DEVIATION REQUEST AND DECISION FORM

Project Name : SF224: The Ridge at Lorson Ranch Filing 1

A deviation from the standards of or in Section **El Paso County Standard Drawing of the Engineering Criteria Manual (ECM) Detail SD 4-20**, is requested.

Exhibit showing Chemical
Grout Locations on The Ridge
at Lorson Ranch Filing 1

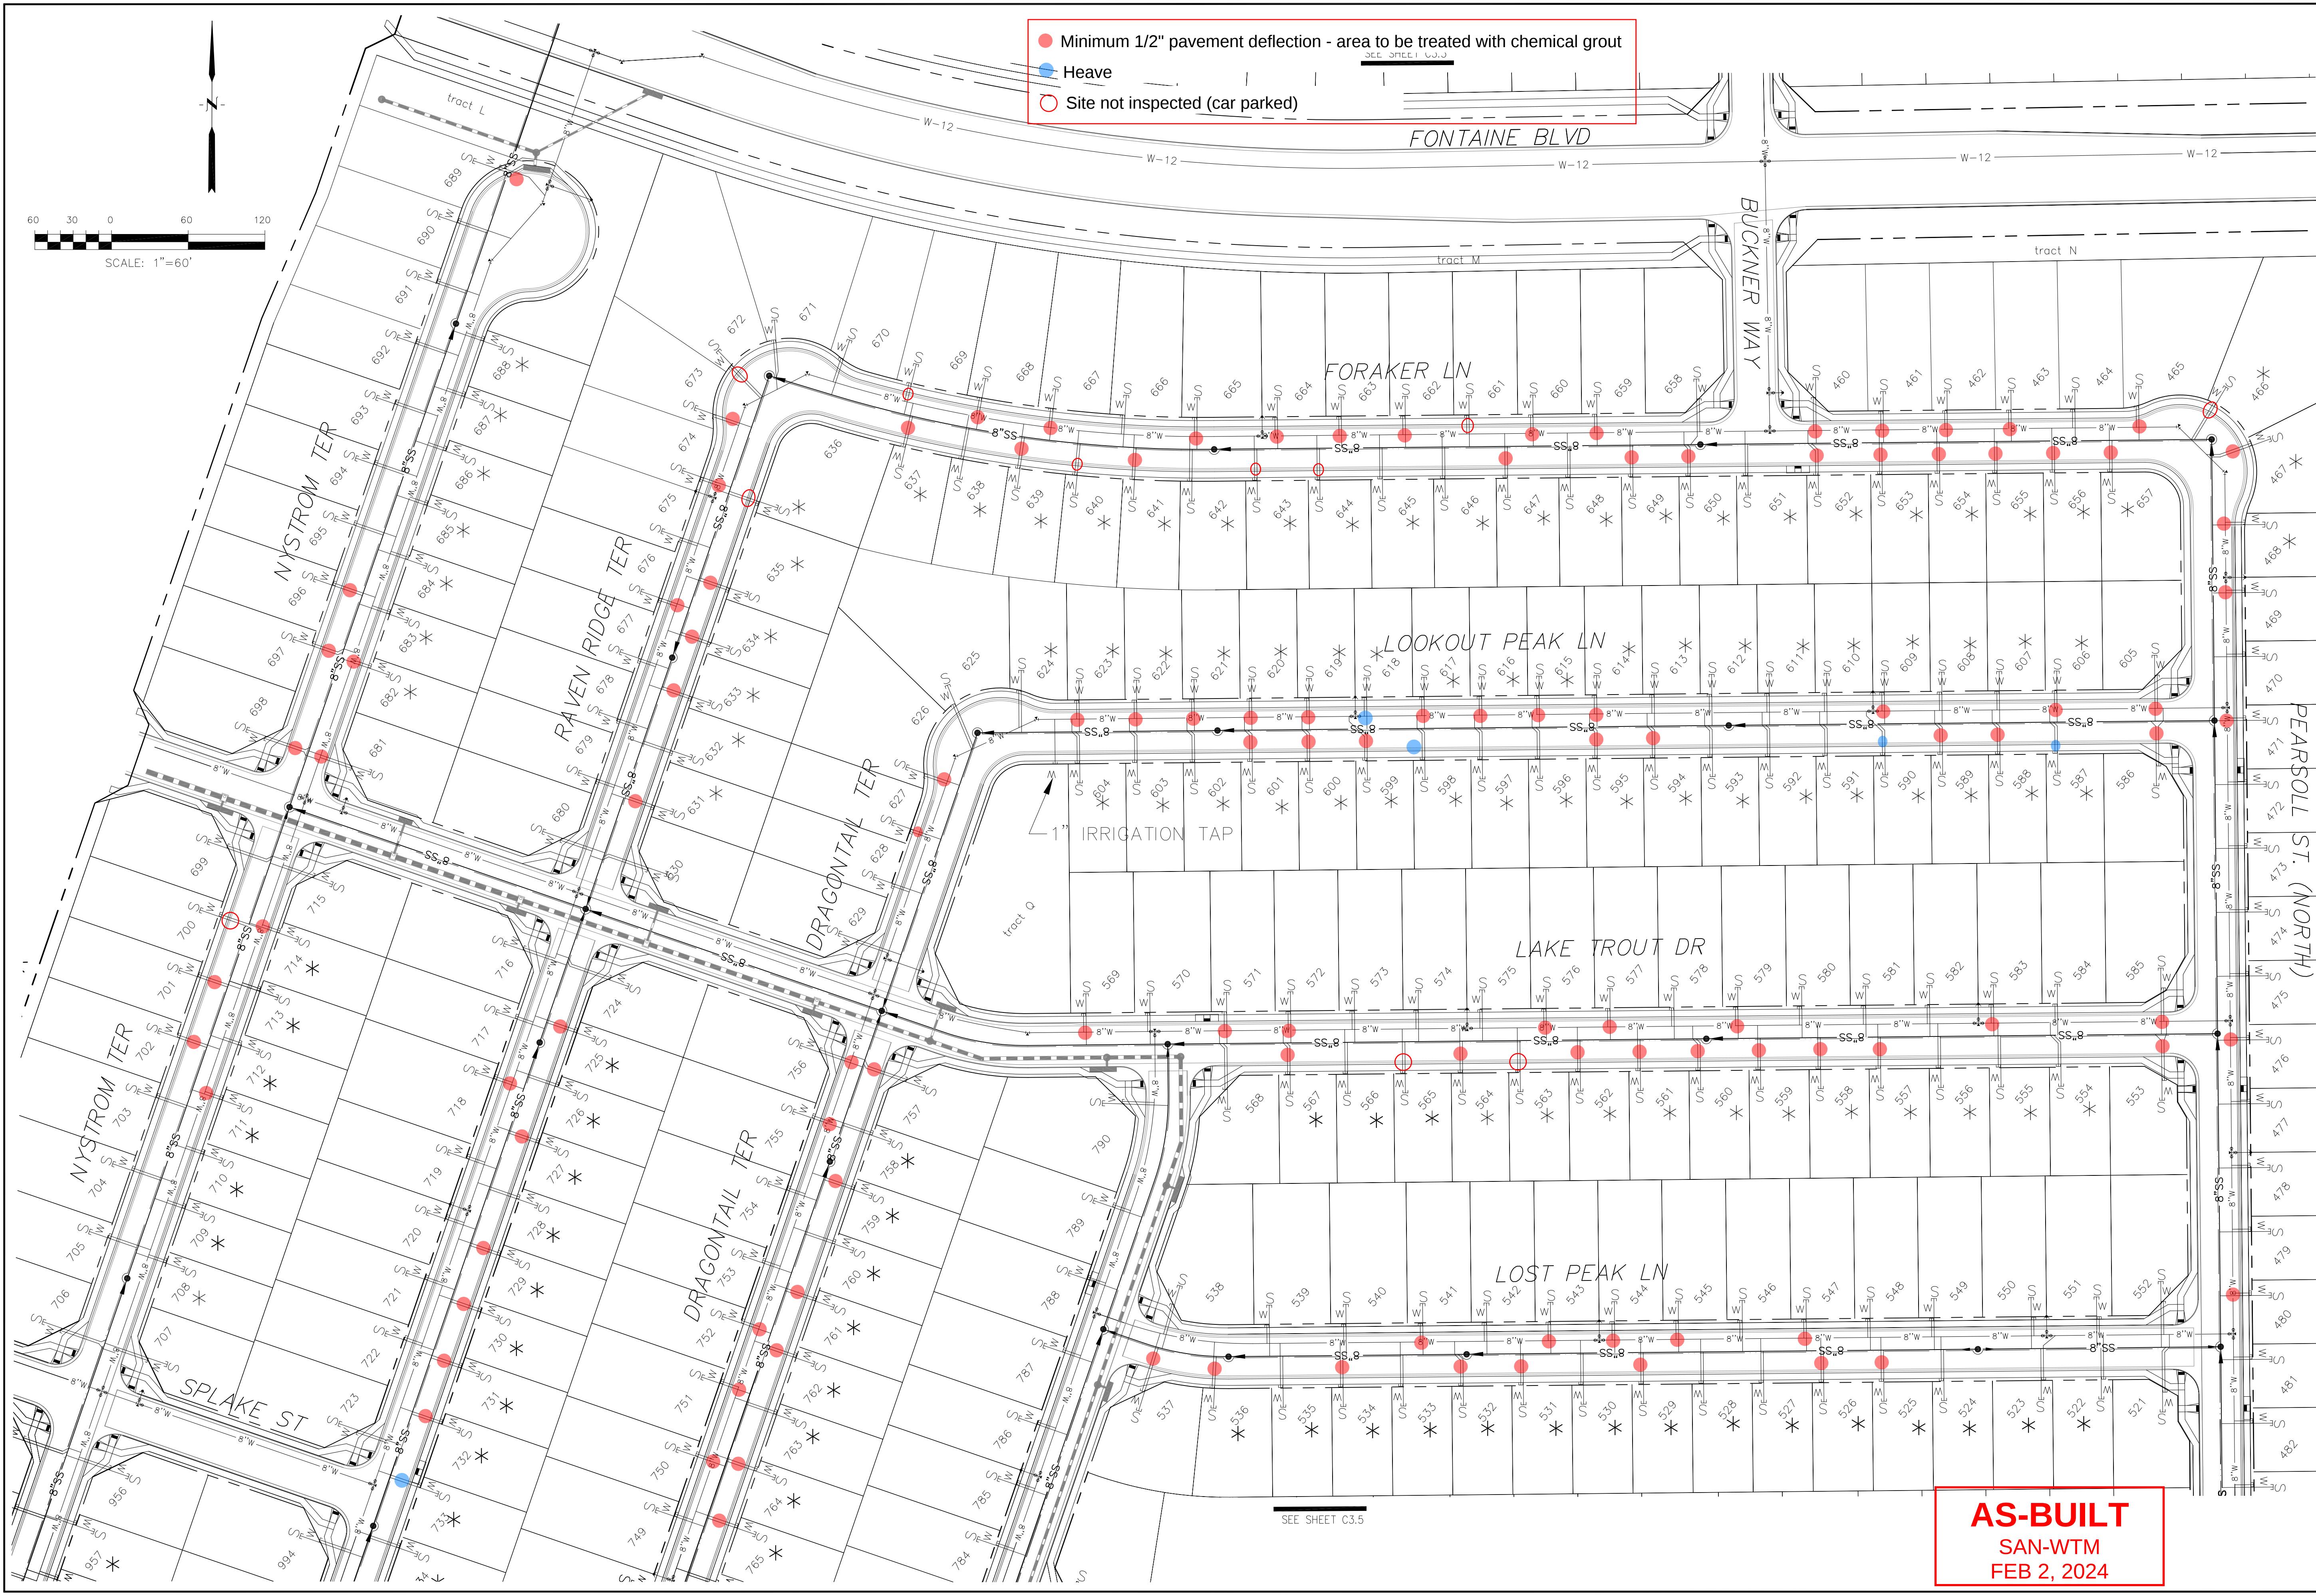
Deviation request for the use of the chemical grout to stabilize the soils within the roadway and utility trenches where settlement and distress were observed and to lift and relevel pavement, concrete flatwork, and stormwater catch basins. The deviation request is requested for The Ridge at Lorson Ranch Filing 1 (File# SF224)

The chemical grout should initially be injected approximately 4 feet on center within the utility trenches through a 1/2" injection rod advanced to a depth no greater than 4 feet below land surface (bls) through 5/8" diameter drilled holes. After an initial stabilizing injection volume that will be determined on a case-by-case basis, the injection rod tip will be raised to approximately 1.5' to 2' bls or within 0' to 1' ft bls of the base of the cement-treated subgrade (CTS) to lift and relevel the concrete slabs or pavement. When being utilized to relevel installed stormwater vaults, concrete sidewalks, or concrete curbs, the material will be injected directly beneath the concrete. The elevations of the pavement/slabs should be monitored continuously during the chemical grouting

C3.5

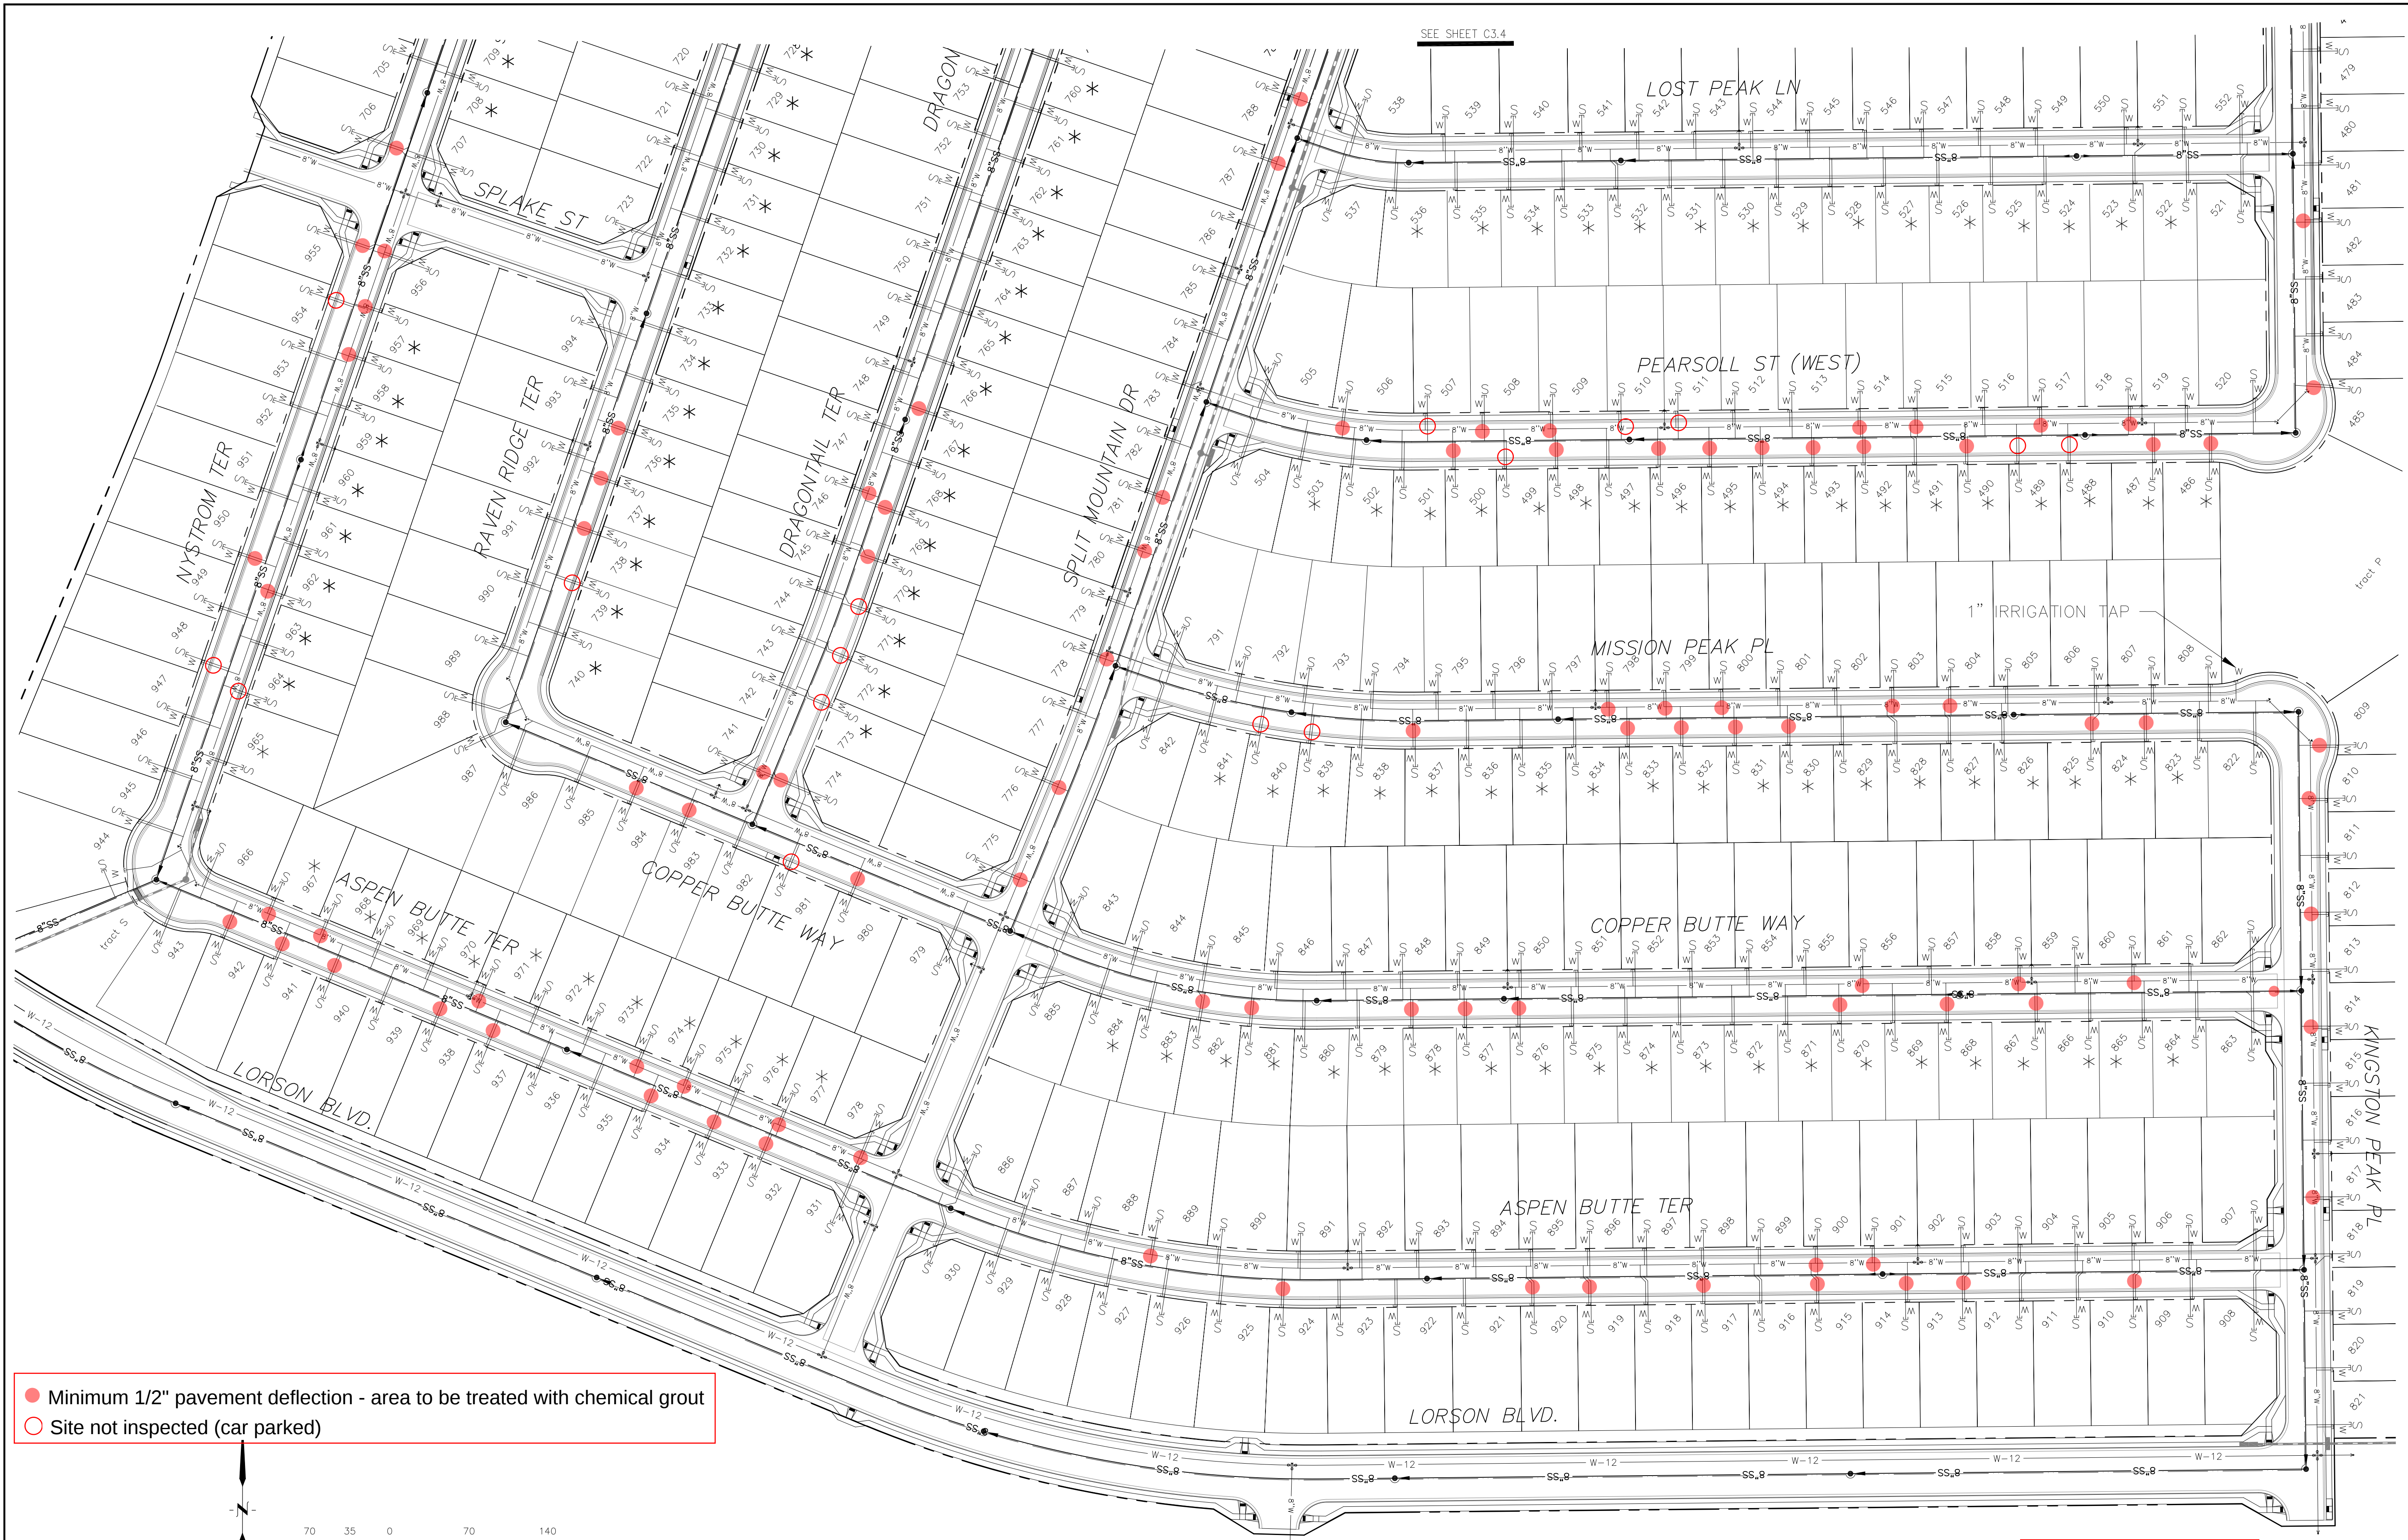
- Minimum 1/2" pavement deflection - area to be treated with chemical grout
- Site not inspected (car parked)
